Project Title: Refurbish Elevators and Replace Controls

Solicitation Questions and Answers
for
Refurbish Elevators and Replace Controls
Project: 437-22-101, RFP: 36C26324R0021
12/15/2024

Solicitation Questions and Answers (updated 3-26-2024) for
 Refurbish Elevators and Replace Controls
 Project: 437-22-101, RFP: 36C26324R0021

3 FLOOR PLAN - ELEVATOR 12 - PIT DEMOLITION
1/4" = 1'-0"

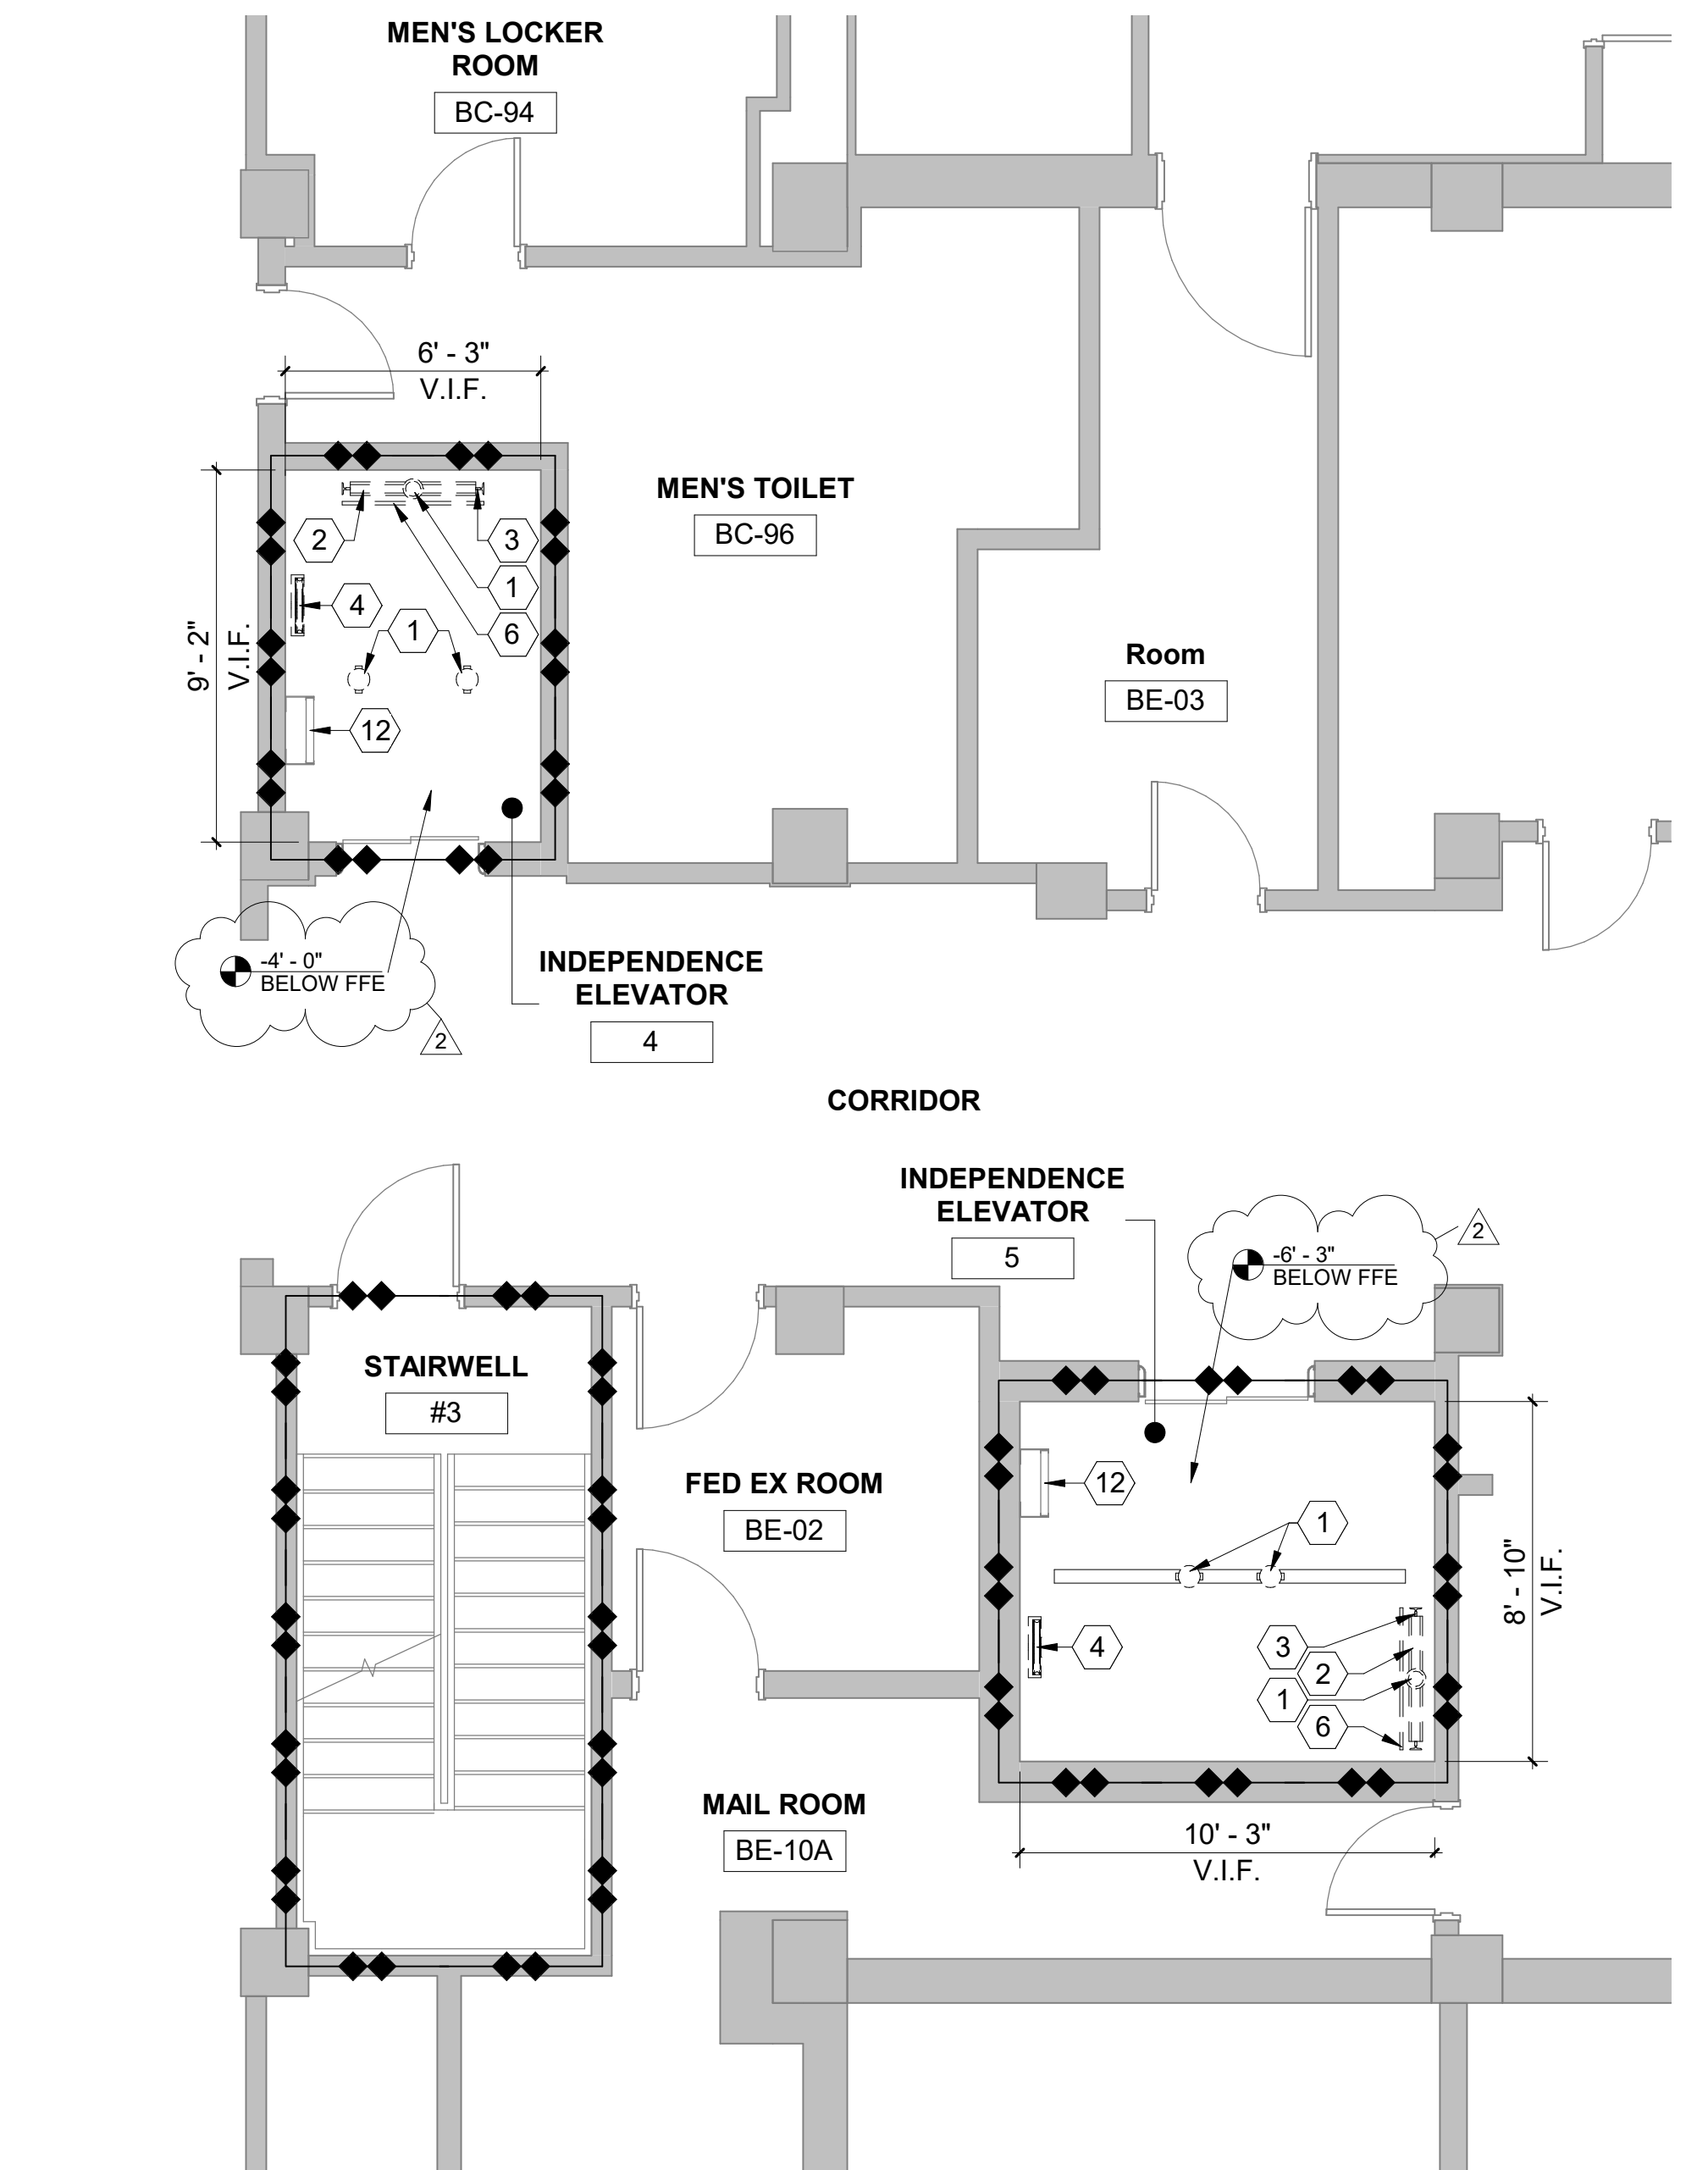
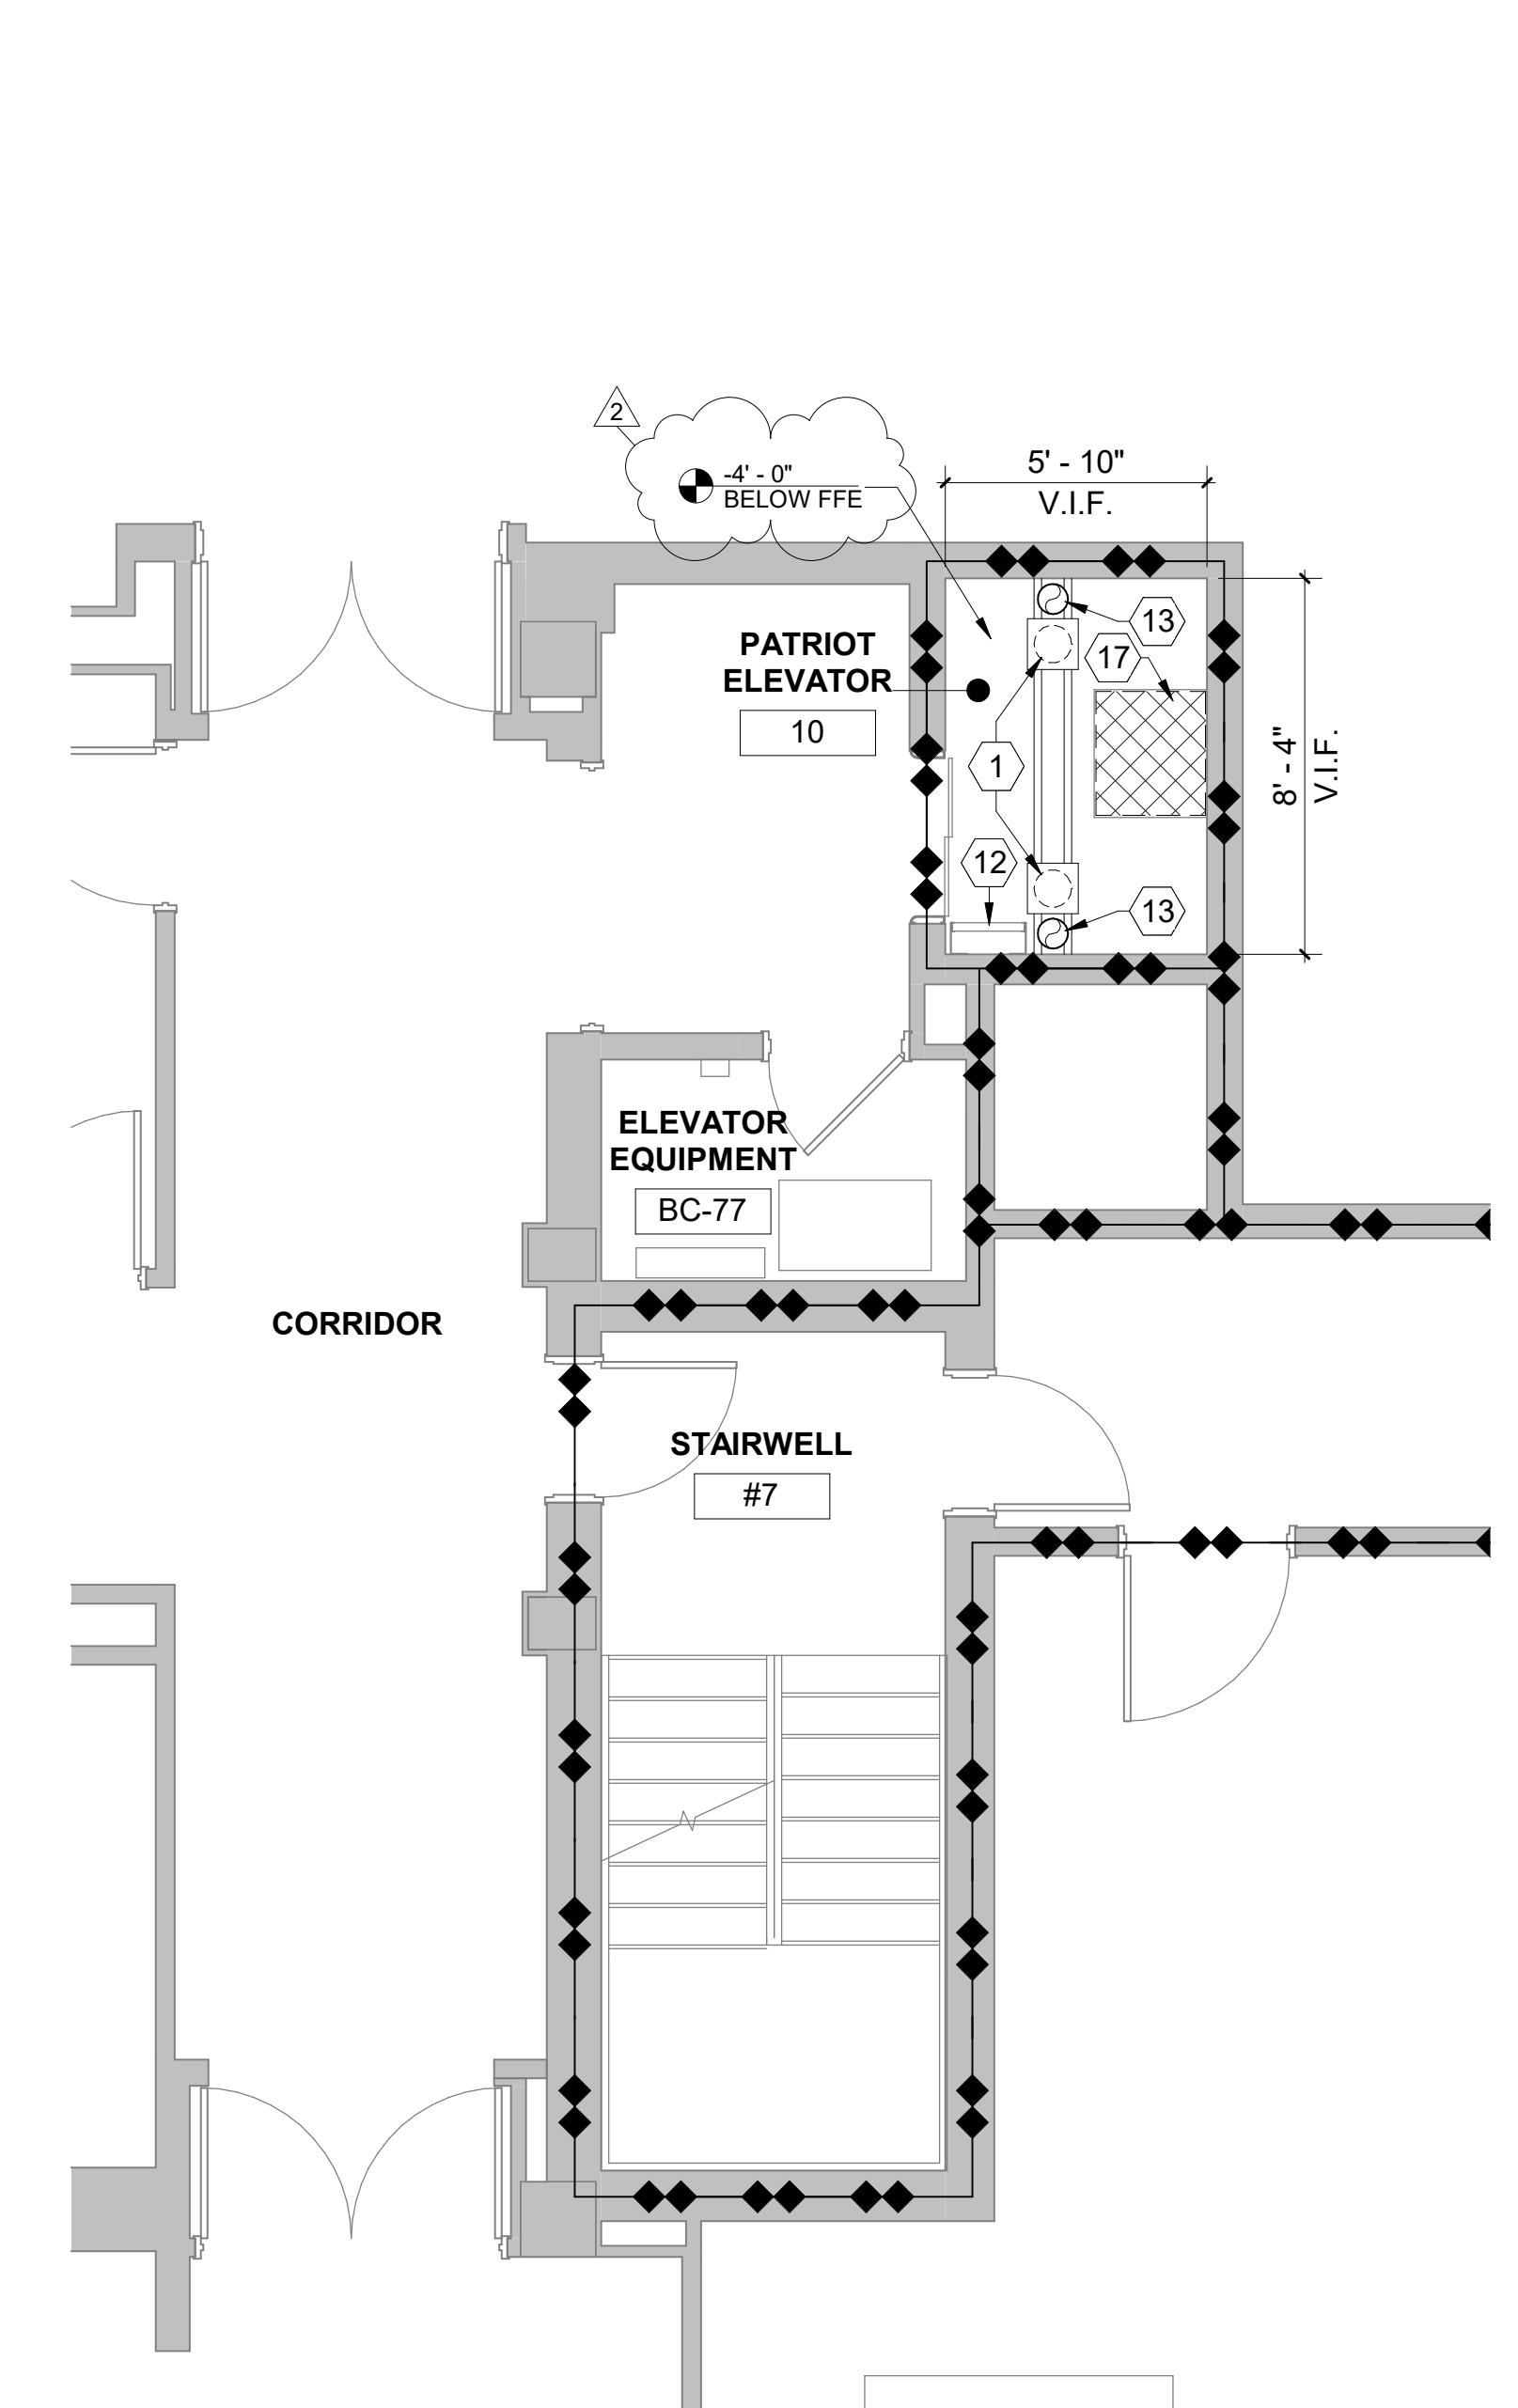
54.	Drawing AD5.20 Key note #12 metal ladders	<p>Per field measurements most ladders in the elevator pit do not meet current code.</p> <p>Are they to remain or be replaced to meet code?</p>	Existing pit ladders to remain. Review on a case-by-case basis will be conducted during construction.

Drawing Sheet AD5.20 ENLARGED PLANS - DEMOLITION – See revised drawing sheet for the adjustment of keynotes # 3, 9, 13 15, 16. Also included is the depth of each elevator pit relative to the floor elevation at the lowest elevator lobby for each hoistway.
